Re: Maider Road Waterfront Site

Site ID No. B00015

We have received your letter dated March 2, 2016 regarding the Department's comments to our Supplemental Investigation / Alternatives Analysis Report, dated December 2015 for the above referenced site. Our responses to Department comments are provided below. Department comments are shown below in italics, while C&S comments and clarifications are shown in bold.

COMMENT 18 UPDATED FIGURE FROM APPENDIX A OF FWRIA

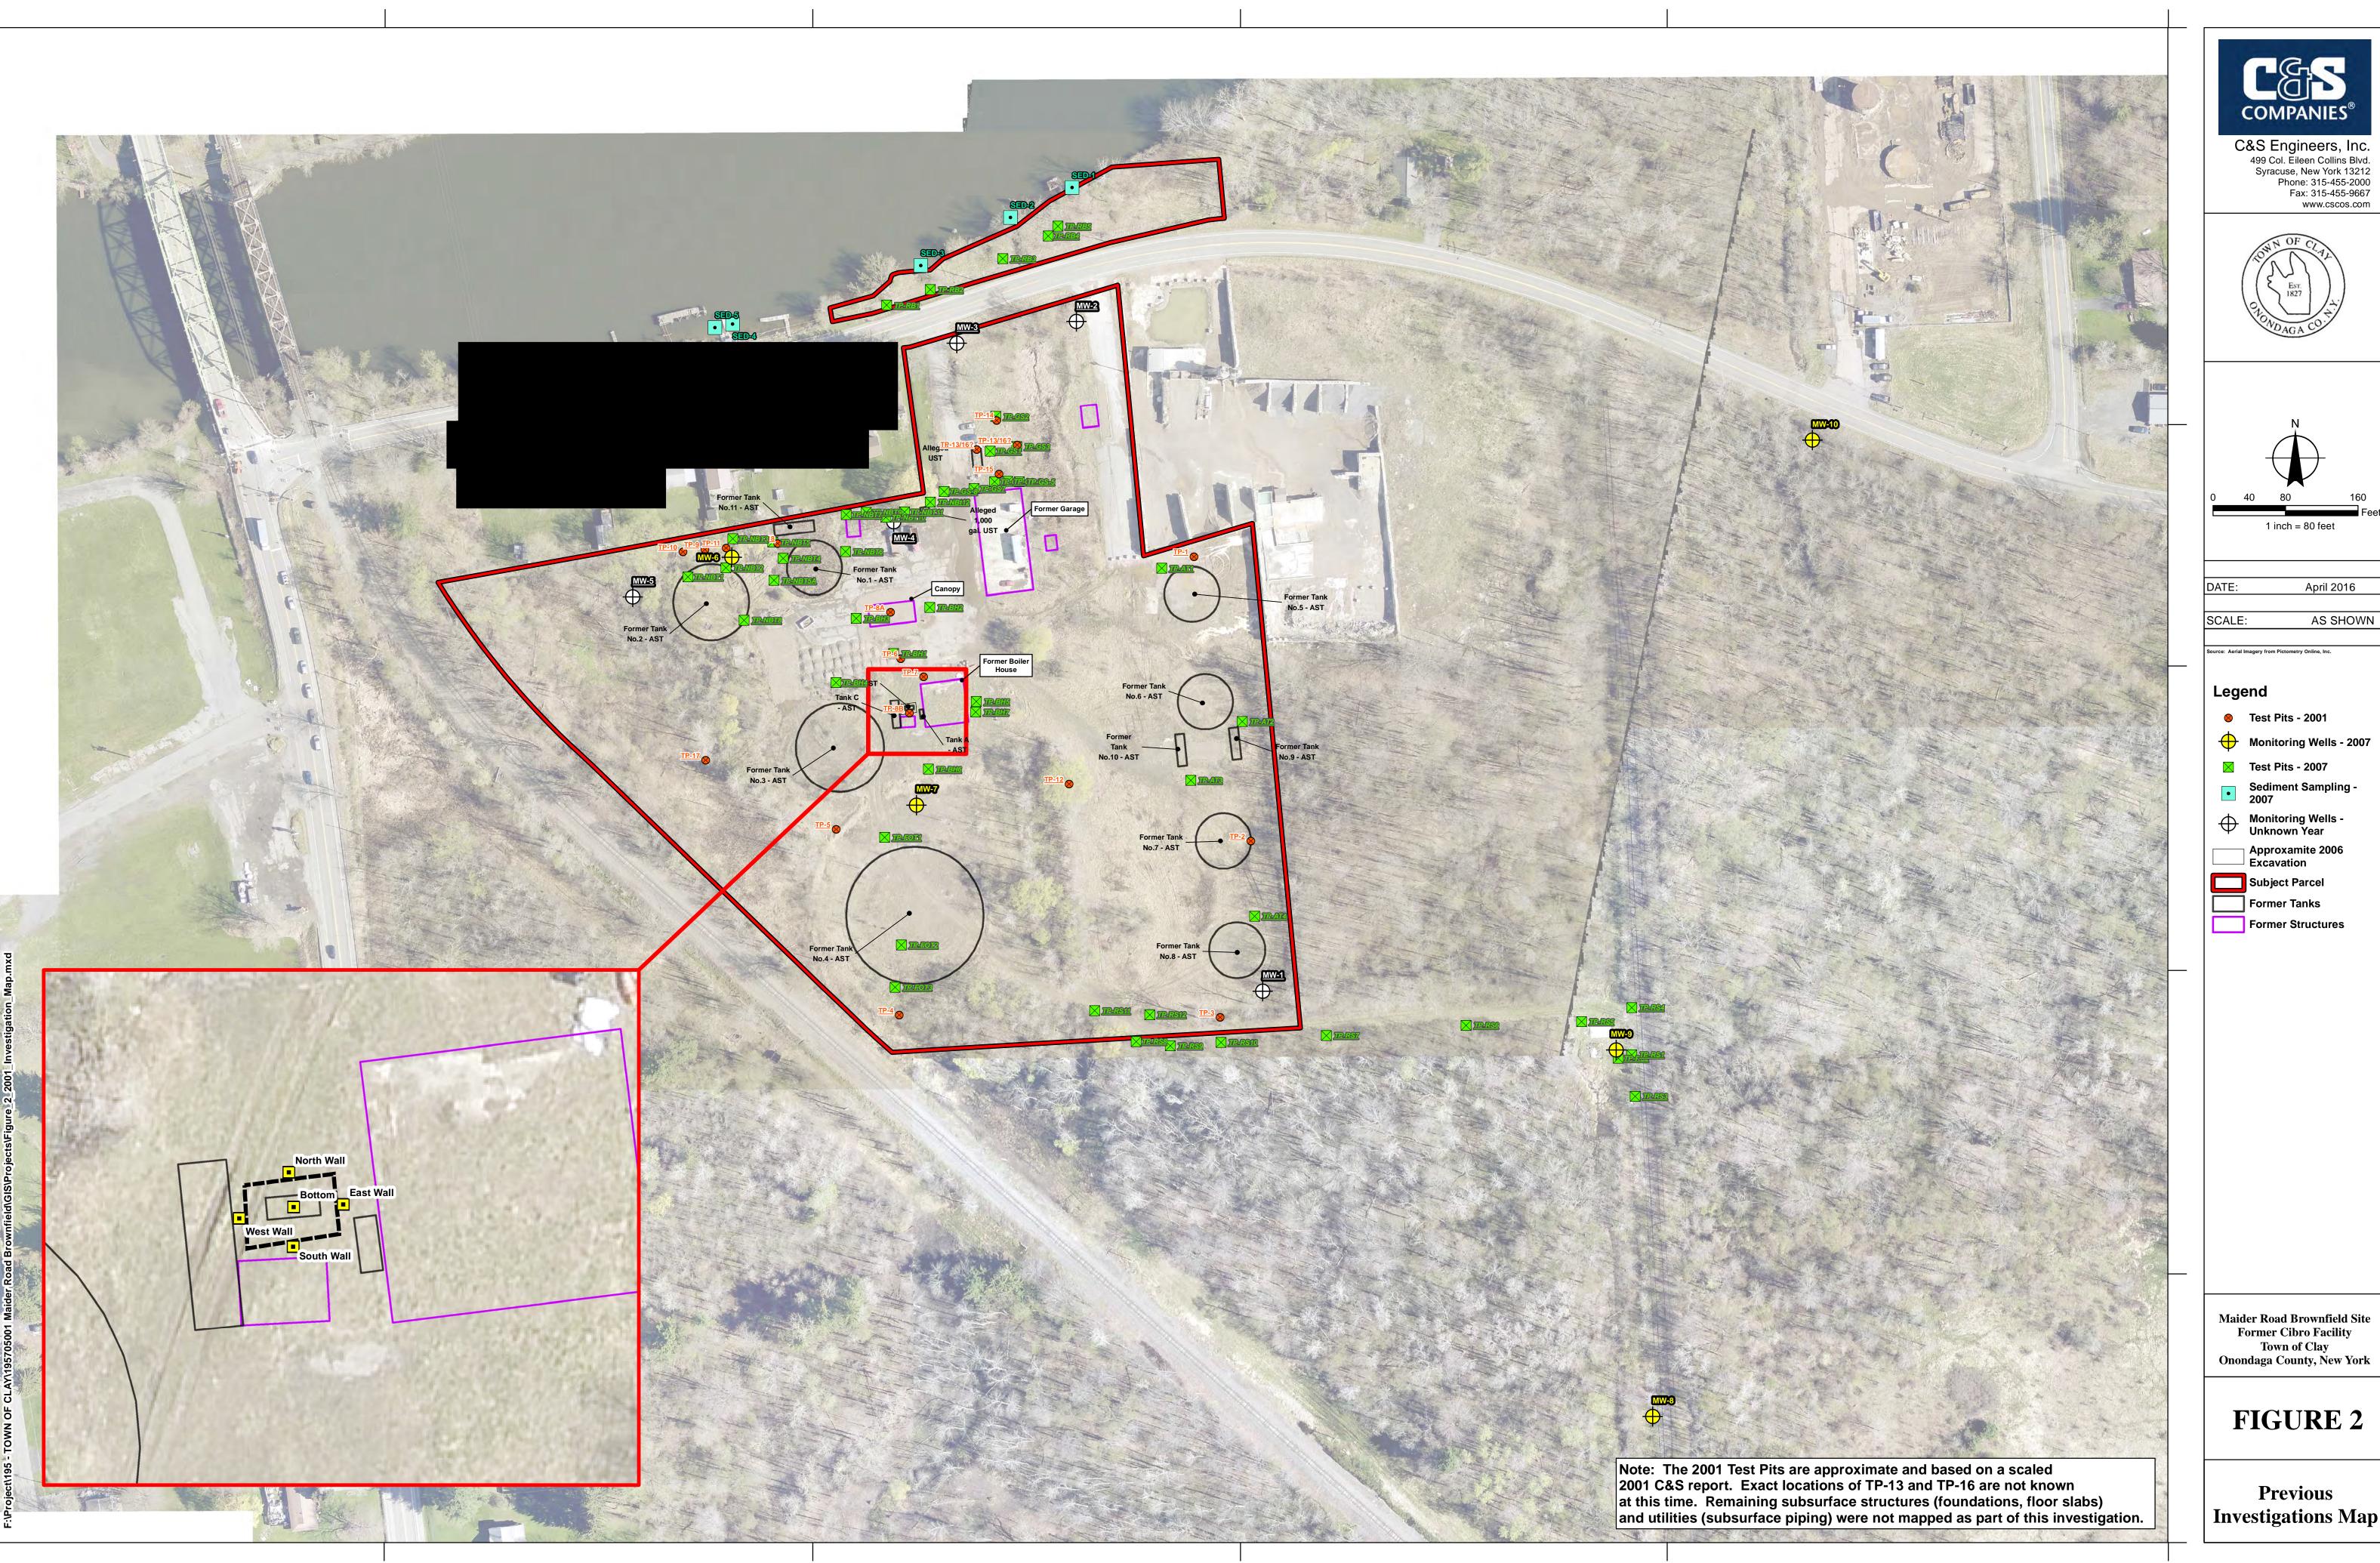
Comment 18: Fish and Wildlife Resources Impact Analysis (FWRIA), Appendix A – Label the wetland areas as identified in Section 1.1.2.1 of the FWRIA (Wetland A, B, and C). Label the locations of the test pits which are included in the photographic log (e.g., W-A-1, W-B-1, etc.) Indicate the locations of the wetland delineation pits from which petroleum odors emanated. Please update the figure in Appendix A of the FWRIA and resubmit the figure.

Response: The figure has been updated accordingly and is attached.

FIGURE 3

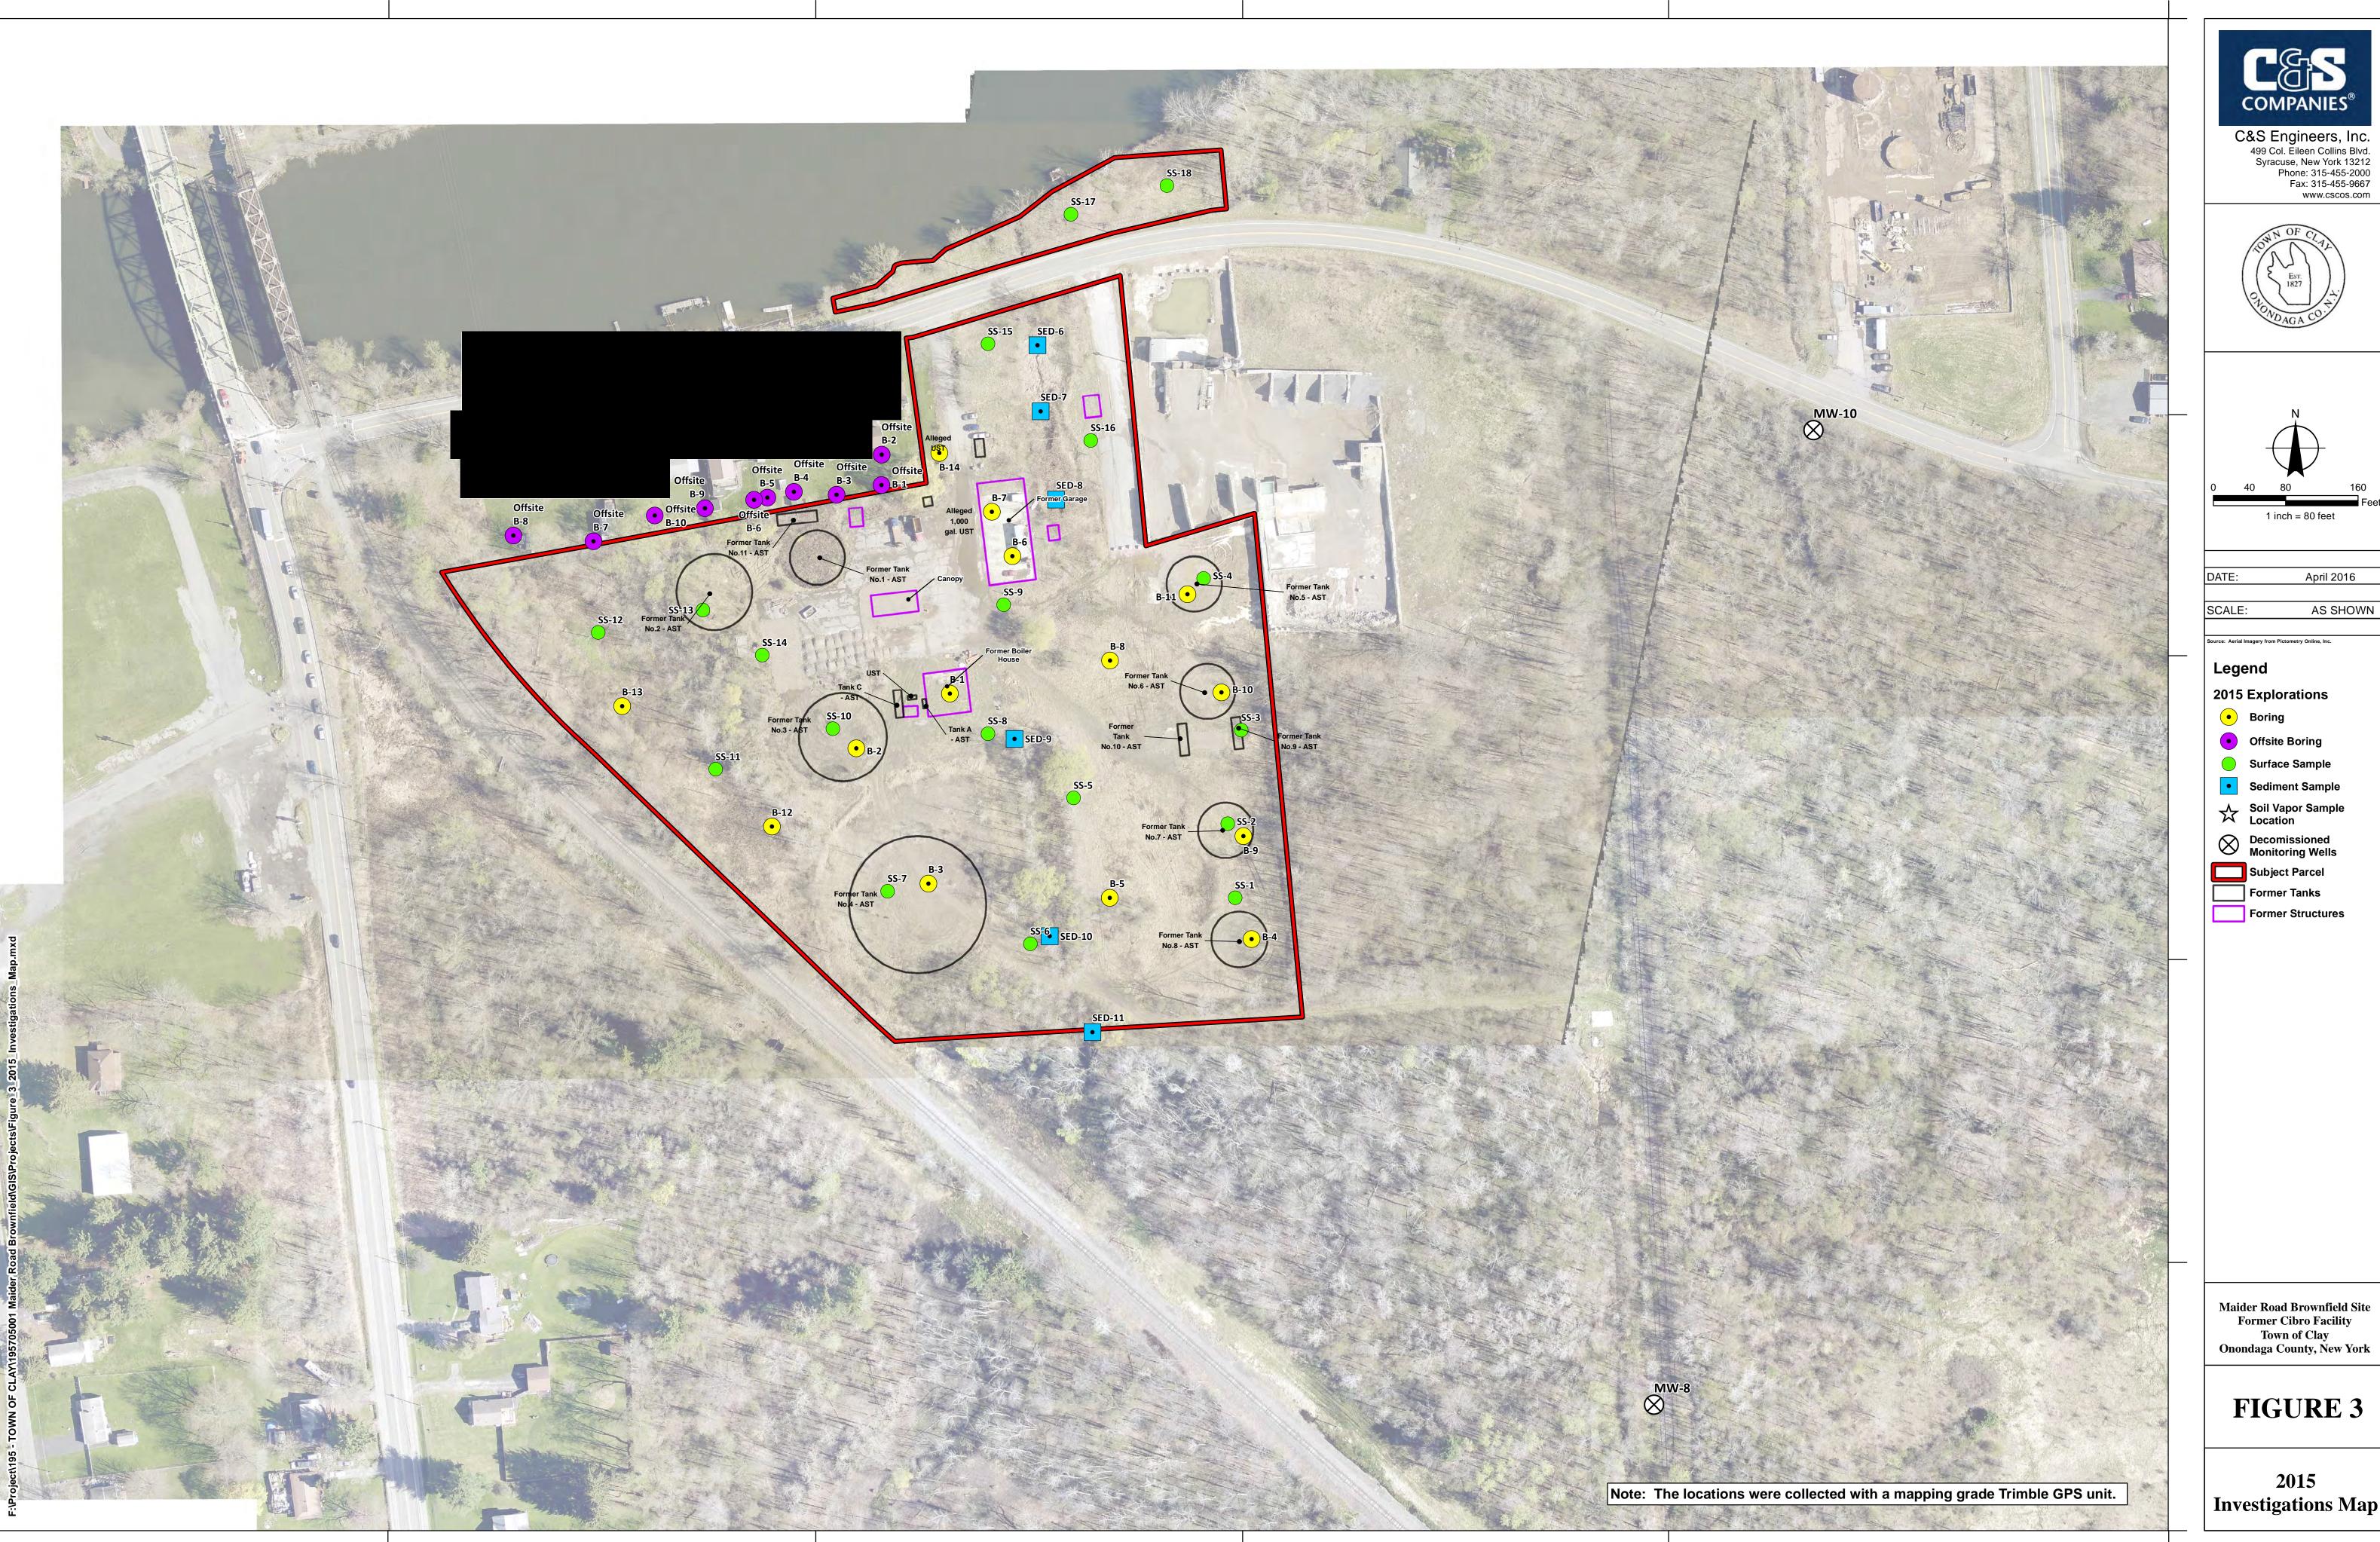
Comment 5: Figures 3 & 4 – The boring labeled as "Off-site B-2" should be "Off-site B-1"; "Off-site B-3" should be "Off-site B-2"; and "Off-site B-1" should be "Off-site B-3". Please make the corrections and resubmit.

Response: We have made the corrections on Figures 2, 3, and 4. The amended figures are attached. Please note the exact locations of TP-13 and TP-16 could not be verified. Field notes indicate soils were similar and both exhibited petroleum odor.

Response: We have relabeled the borings on Figures 3 & 4. The amended figures are attached.
